MILPITAS PLANNING COMMISSION AGENDA REPORT

Meeting Date: October 12, 2011

APPLICATION: MAJOR TENTATIVE MAP NO. MT11-0003, SITE DEVELOPMENT PERMIT NO. SD11-0012 AND CONDITIONAL USE PERMIT NO. UP11-0033, CONTOUR PROJECT

Figure 2.
Open Space Exhibit and Landscaping Plan

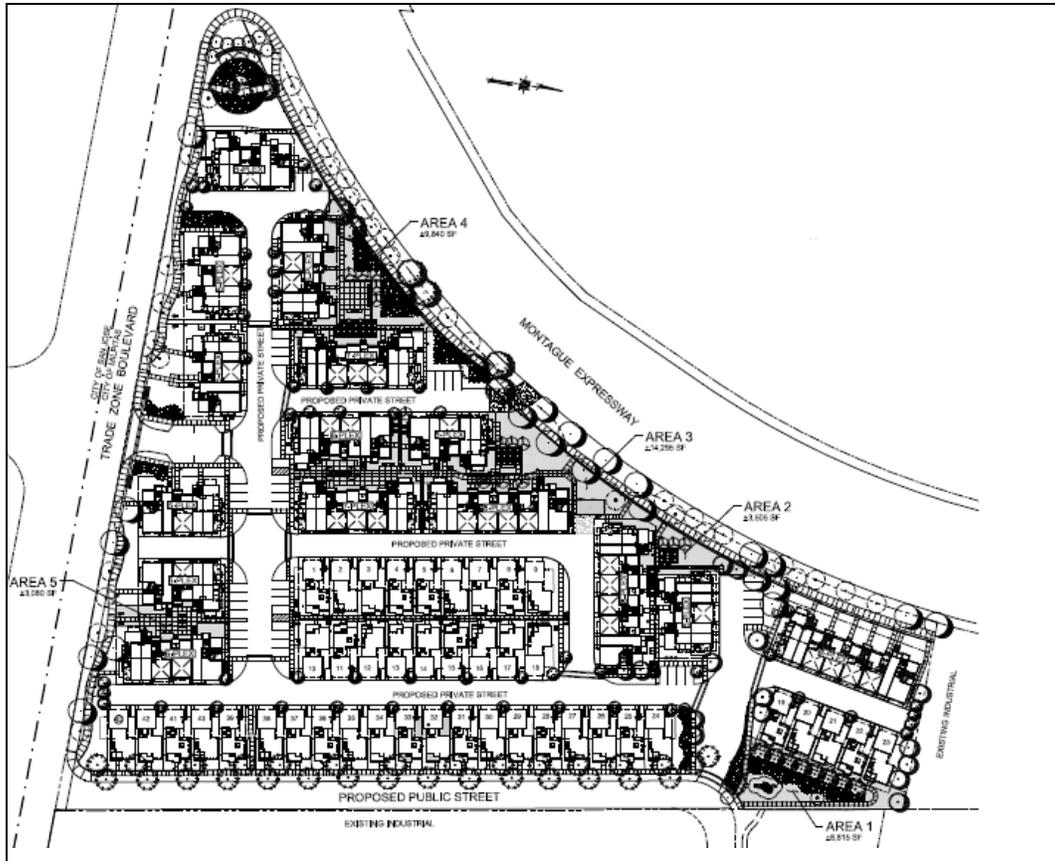
The project proposes approximately 0.89 acres of private usable open space which includes a 0.20 acre private park that will be improved with a play structure and picnic seating areas and approximately 0.69 acres of outdoor gathering spaces that are located in certain paseos and along the Montague frontage as depicted in Figure 2 on the preceding page. The private gathering spaces provide outdoor areas designed with BBQ and seating amenities. *Staff recommends the following conditions:*

- 1. Increase the size of the 15 gallon Ginkgo trees to a 24-inch boxes tree size in private park area to provide shading over the picnic areas.*
- 2. Prior to building permits, the applicant shall submit a gateway concept at the open space area near the Montague/Trade Zone Intersection for Planning Division review and approval.*
